CITY OF DOVER

PLANNING TECHNICAL REVIEW COMMITTEE –AGENDA

PLAN SNAPSHOT REPORT SITE-2023-0011 FOR CITY OF DOVER, N.H.

Plan Type: Site Plan - Major
Work Class: New Construction
Status: Review Expired
Valuation: \$0.00
Description: Proposed 3,300 sq ft - Bank with Drive-Up ATM

CLEARANCE BAR DETAIL

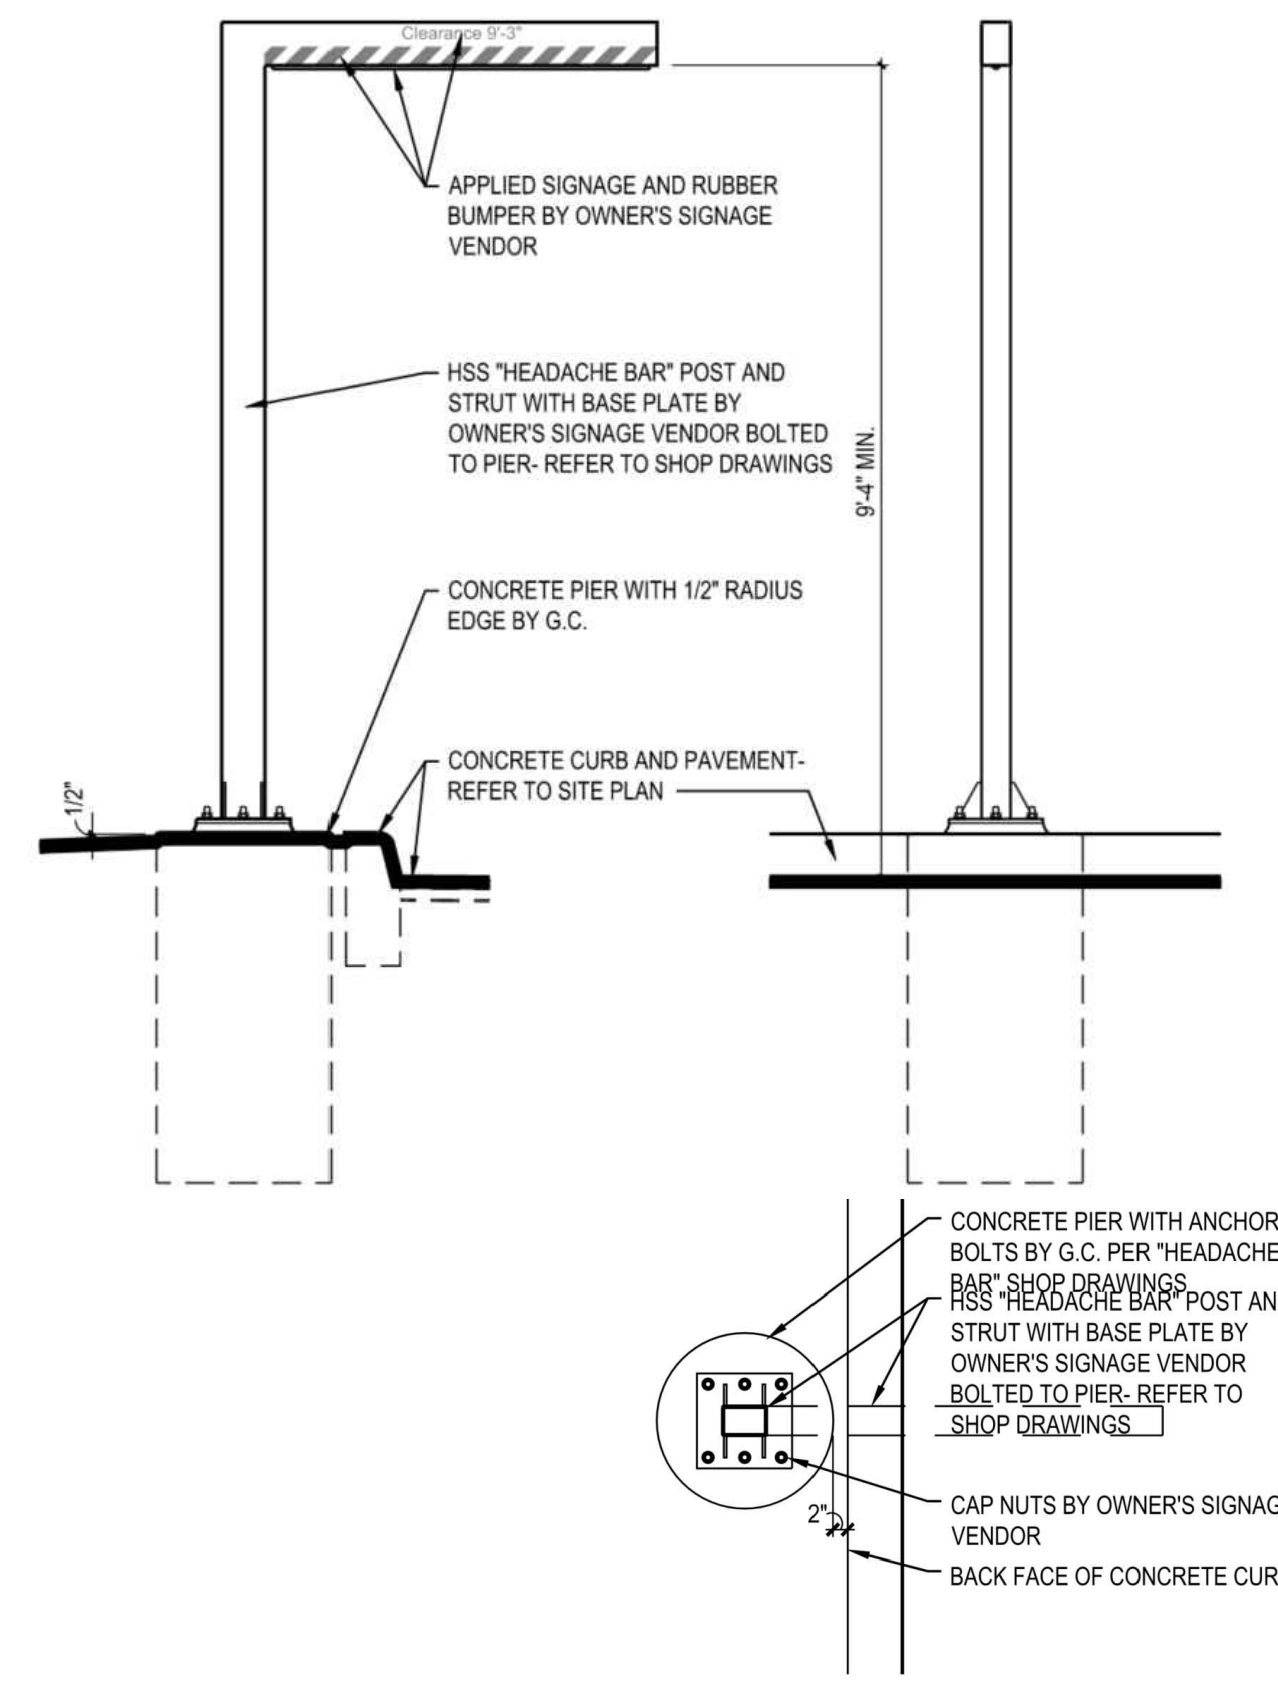
- o Curbing in City right of way shall be granite.
- Sheet C-13:
- o Provide minimum frost depth on detail no. 8.
- o Provide details on foundation for clearance bar. Notes appear to be scanned and are not legible.

The clearance bar foundation has been included within the detail, the final specifications will be approved as a shop drawing prior to construction. Refer to the updated detail on Sheet C-14.
